Watts Bar Nuclear Plant, Unit 2
NRC Docket No. 50-391

Subject: Watts Bar Nuclear Plant (WBN) Unit 2 – Response to Request for Additional Information (RAI) Regarding June 28, 2011 NRC Audit – Steam Line Break (SLB) and other Miscellaneous RAIs

Enclosure 3
TVA Letter Dated July 29, 2011
FSAR mark-ups for SLB transients

Watts Bar Unit 2 Hot Zero Power Steam Line Break with Offsite Power Available –Nuclear Power Versus Time

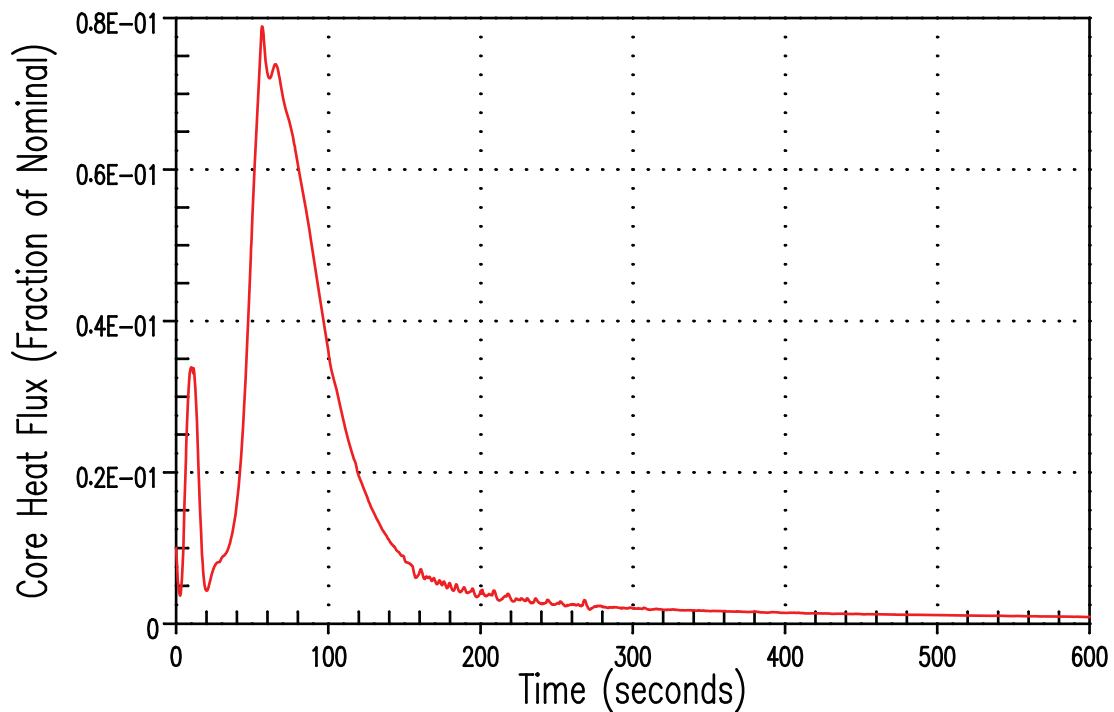
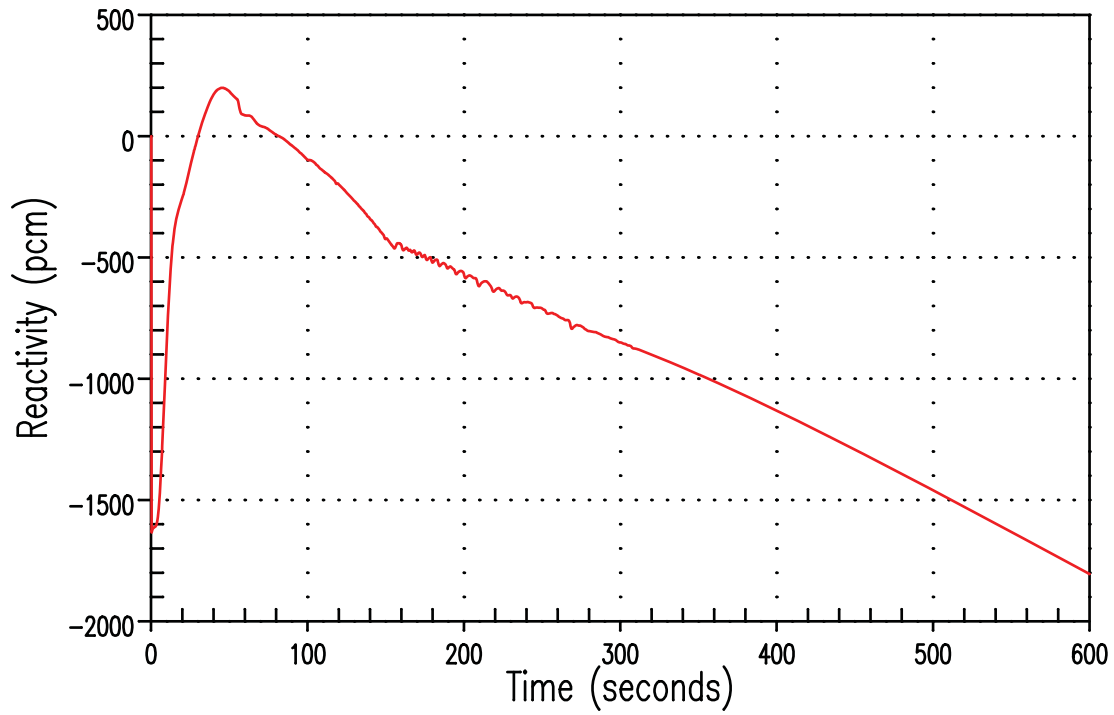
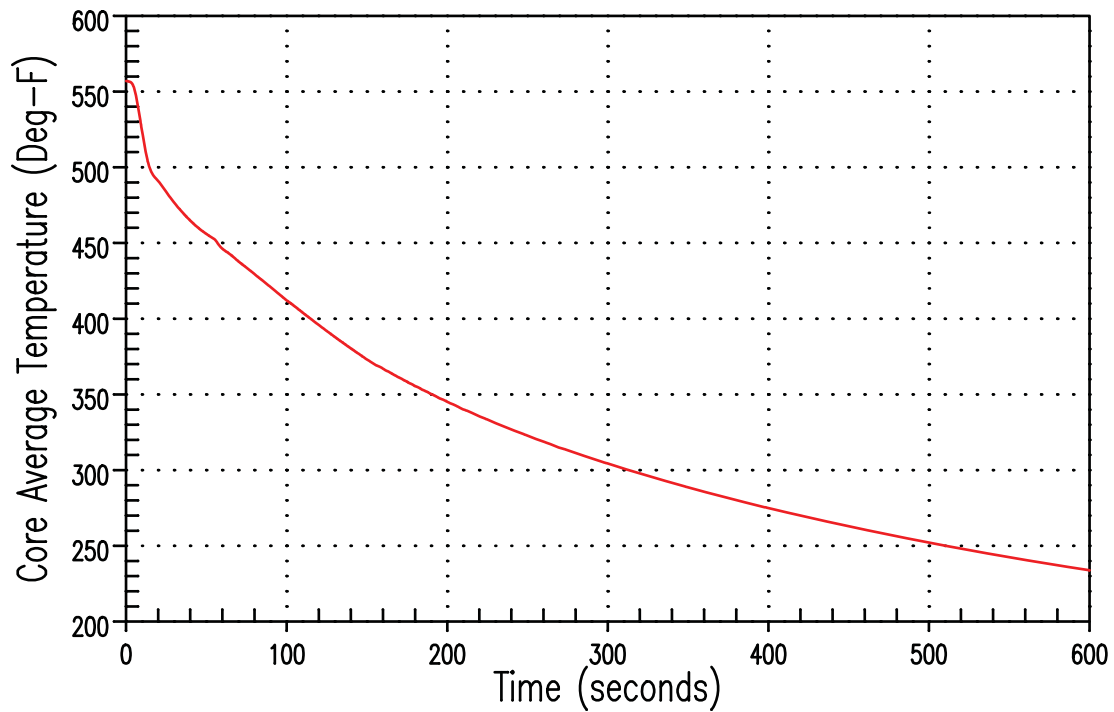
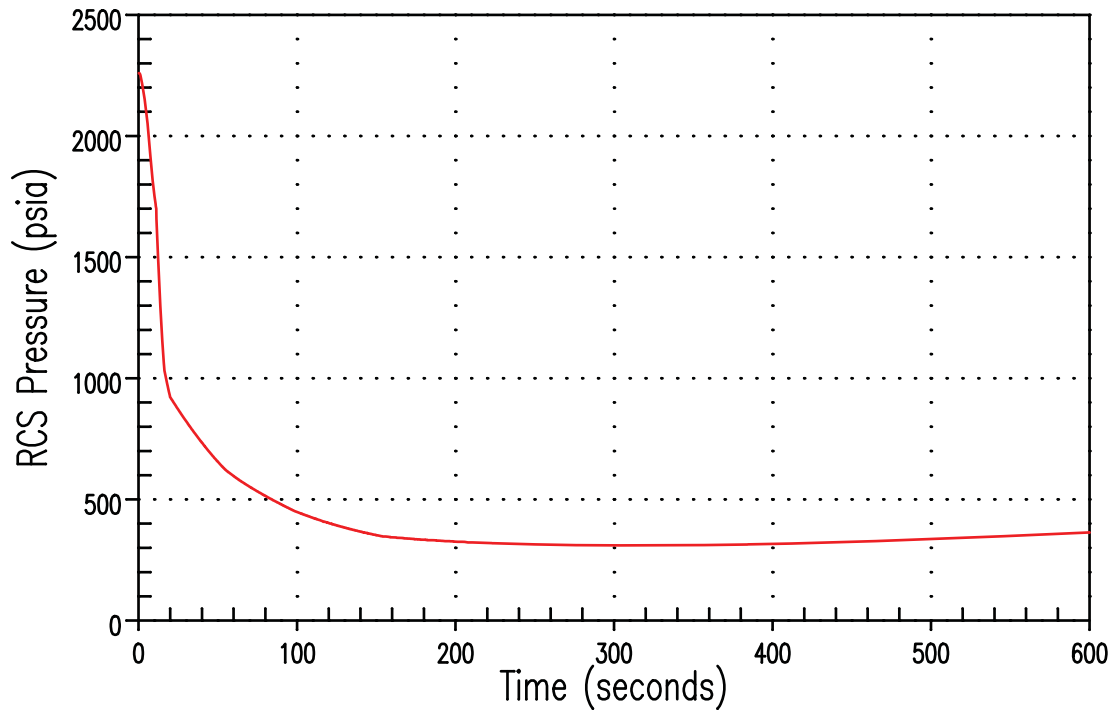
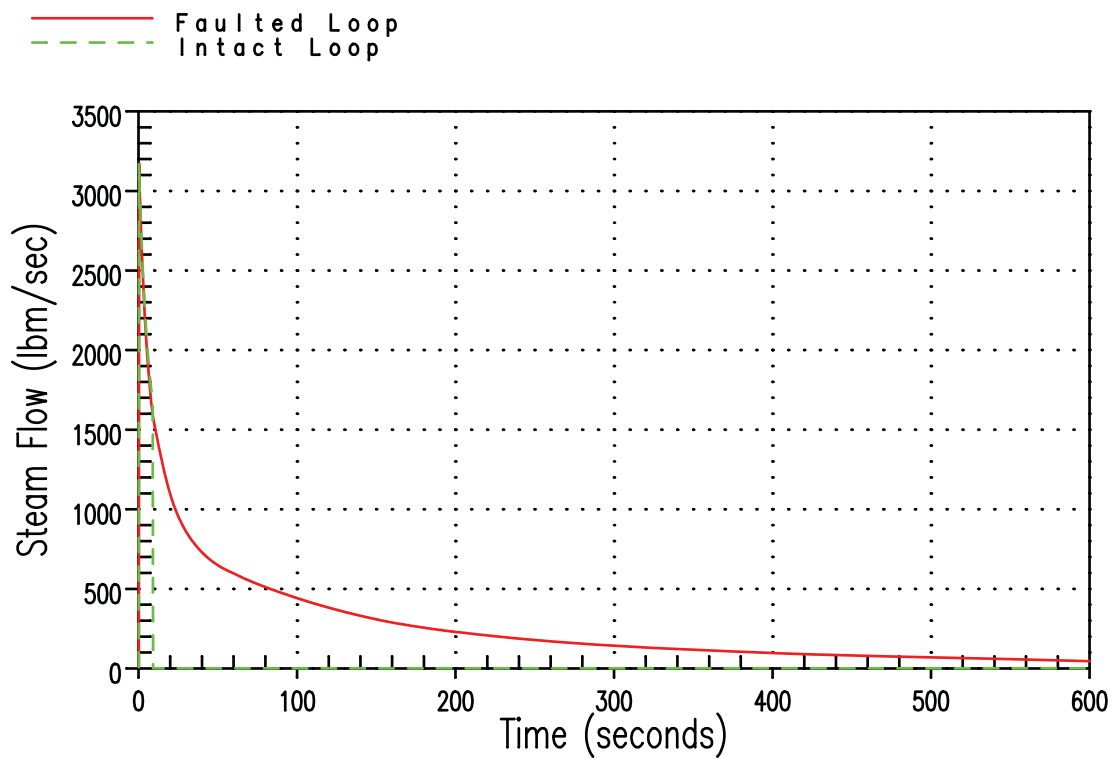
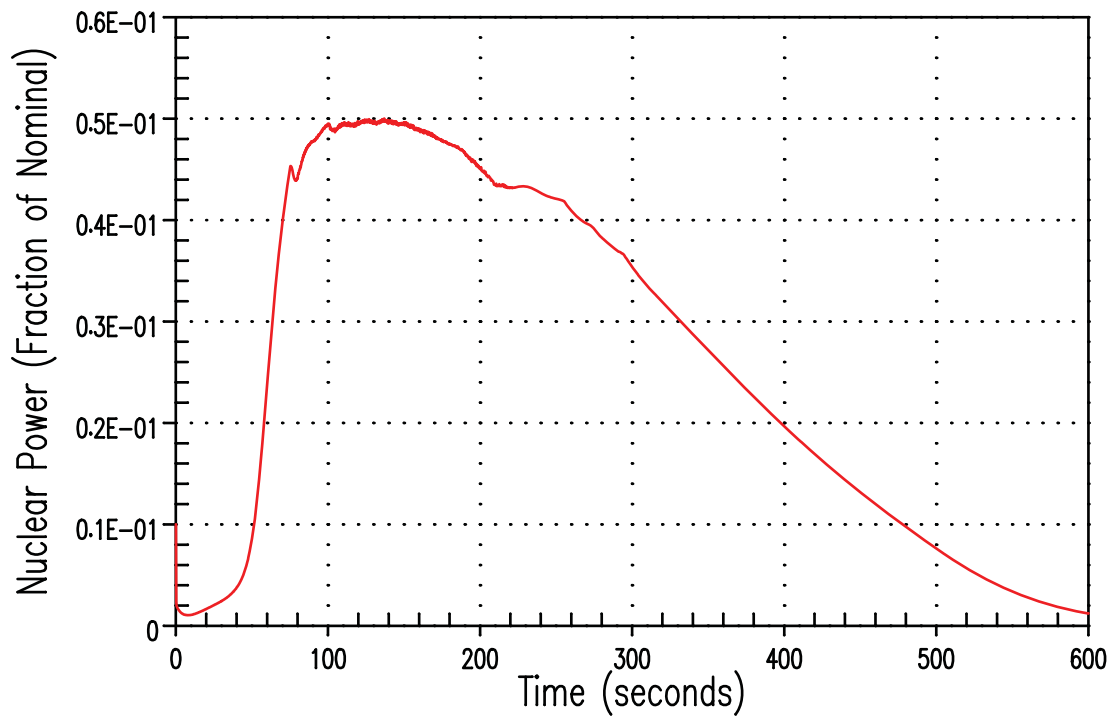
1. A comparison of the differences between the Watts Bar Unit 1 and Watts Bar Unit 2 analyses.
2. A quantification of the benefit for Watts Bar Unit 2 to maintaining a shutdown margin of 1.6% compared to a shutdown margin of 1.3%.
3. A revised steamline break analysis modeling the more conservative Unit 1 reactivity model. This will ensure that the peak power reached in the with offsite power case bounds the peak power reached in the without offsite power case.

3. The Watts Bar Unit 2 analysis was revised to model the Doppler temperature coefficient that was used in the Unit 1 RSG analysis. This resulted in the peak power in the with offsite power case that is greater than the peak power in the without offsite power case. The limiting statepoint for the with and without offsite power cases are presented below along with a table which lists the sequence of events for each case. Additional plots of the key transient parameters are presented on the following pages.

Figure 15.4-11a Transient Response to Steam Line Break with Safety Injection and Offsite Power (CASE A)

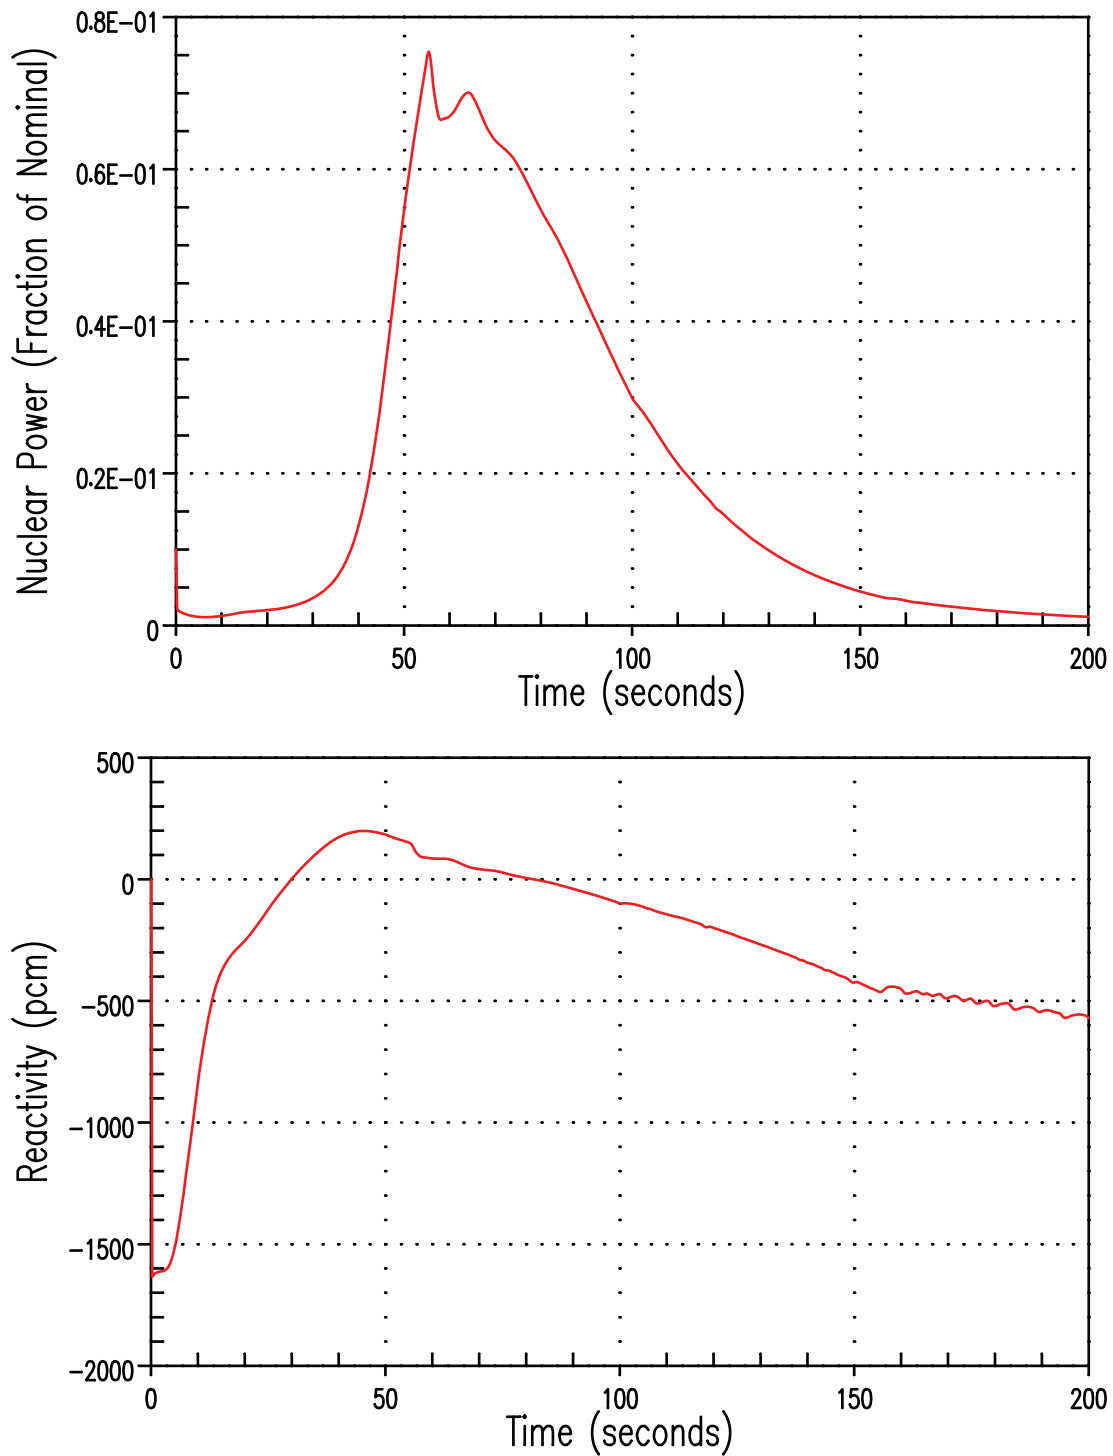
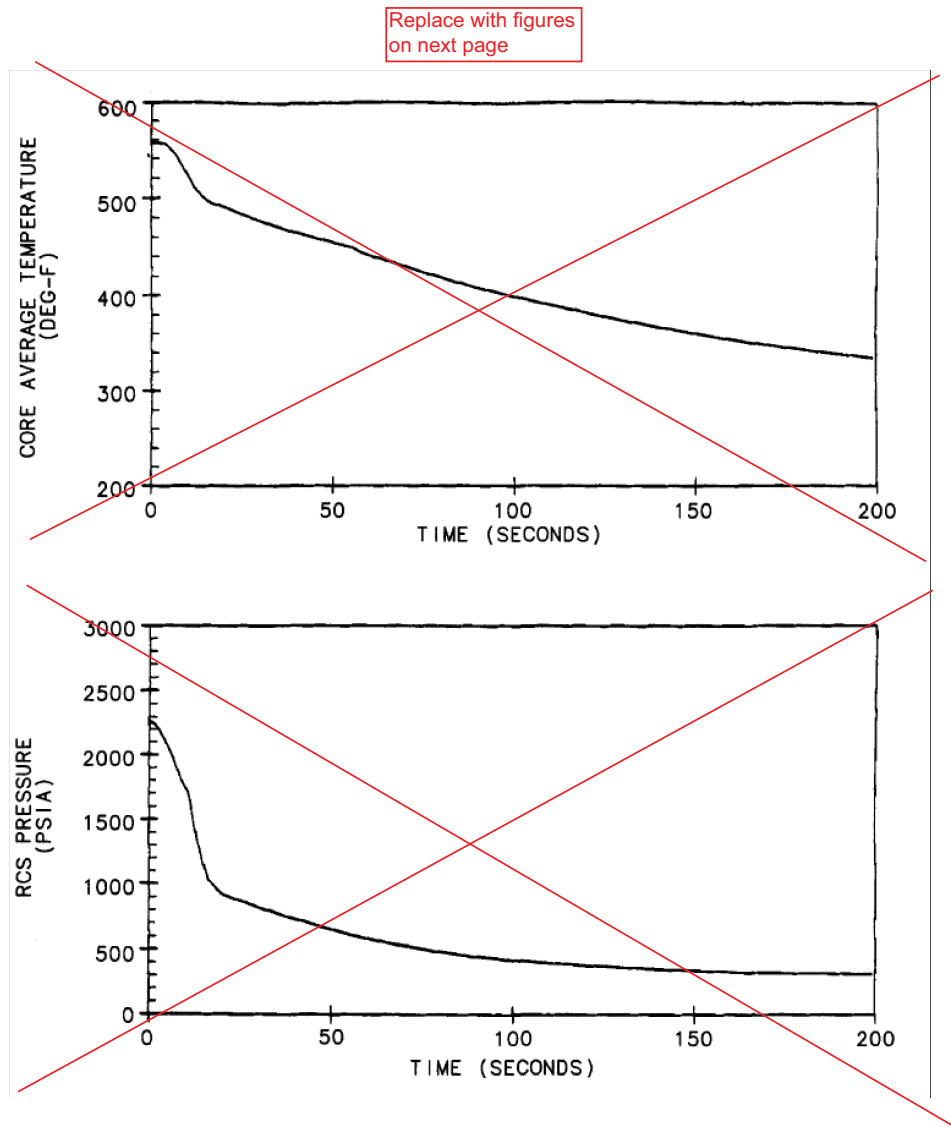
Replace with figures
on next page

As shown in Figure 15.4-11a the core attains criticality with the RCCAs inserted (with the design shutdown assuming one stuck RCCA) shortly after boron solution at 2000 ppm (which is bounding for higher boric acid concentrations) enters the reactor coolant system. A peak core power less than the nominal full power value is attained.

Figure 15.4-11b Transient Response to Steam Line Break with Safety Injection and Offsite Power (CASE A)

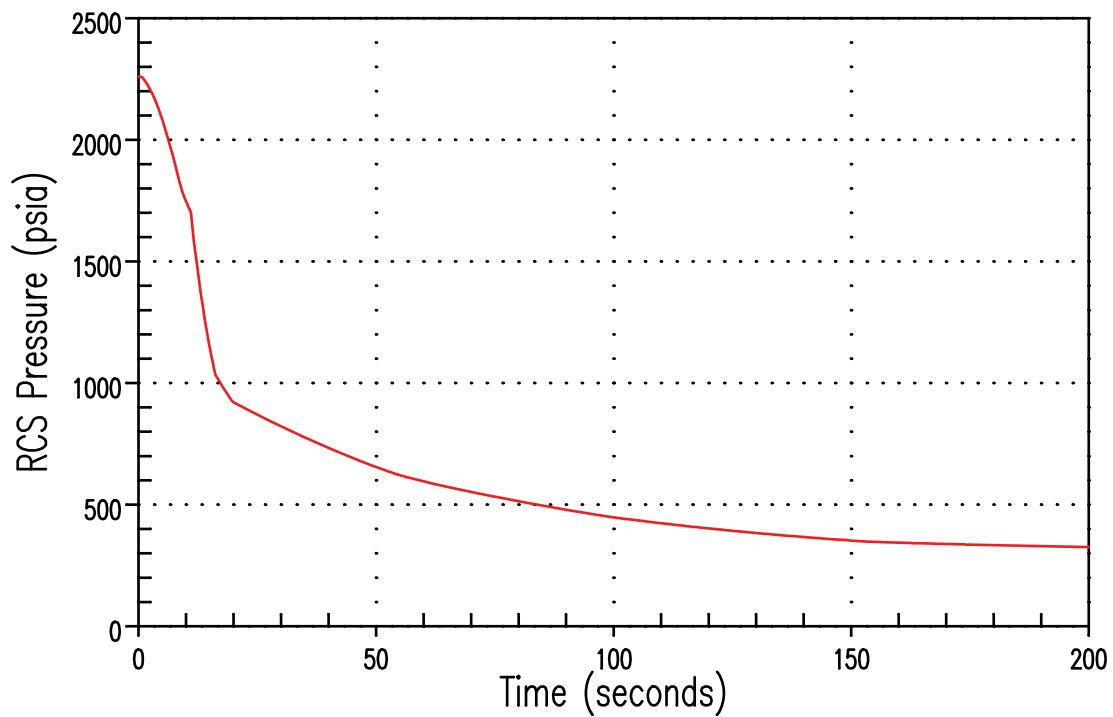
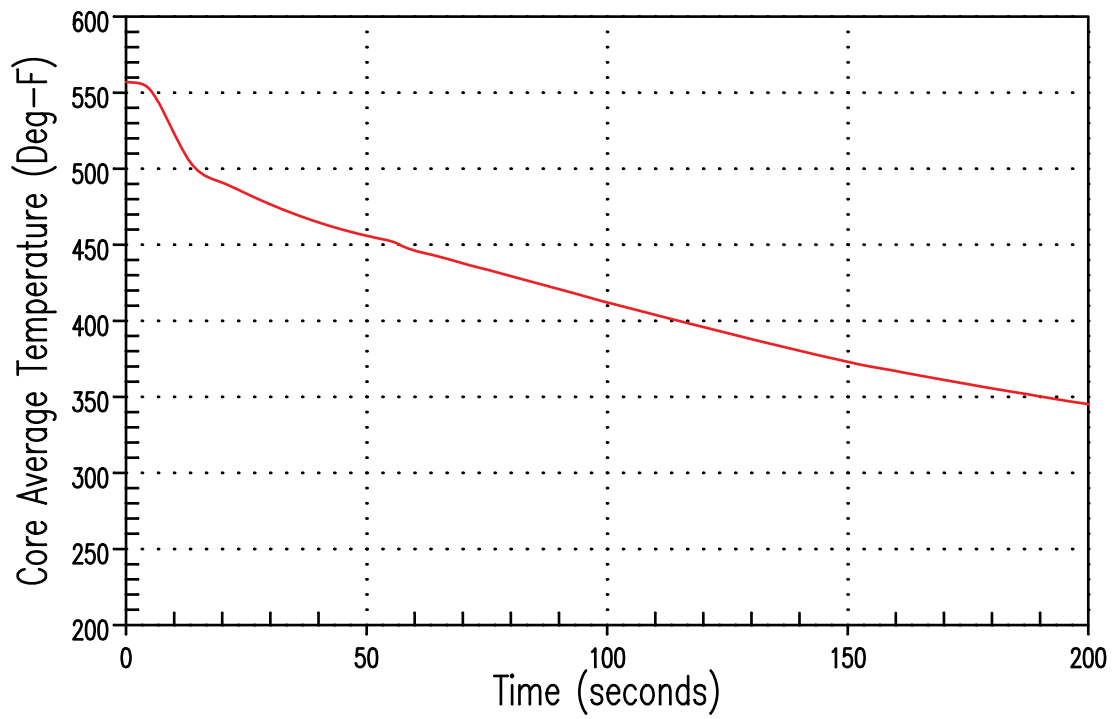
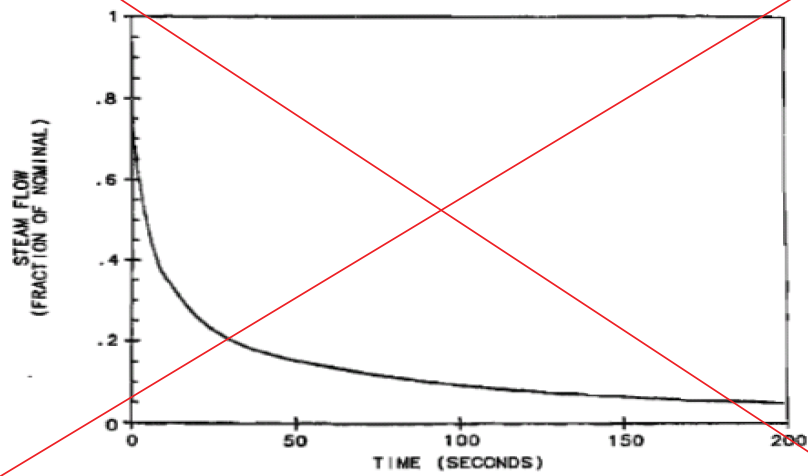
It should be noted that the safety injection accumulators are actuated in Case (a) due to low RCS pressure (Figure 15.4-11b). Once the accumulators actuate, 2400 ppm boron is delivered to the core and the transient is terminated before a significant return to power is achieved. Once the transient is terminated and the plant is stabilized, emergency operating procedures may be followed to recover from the MSLB event.
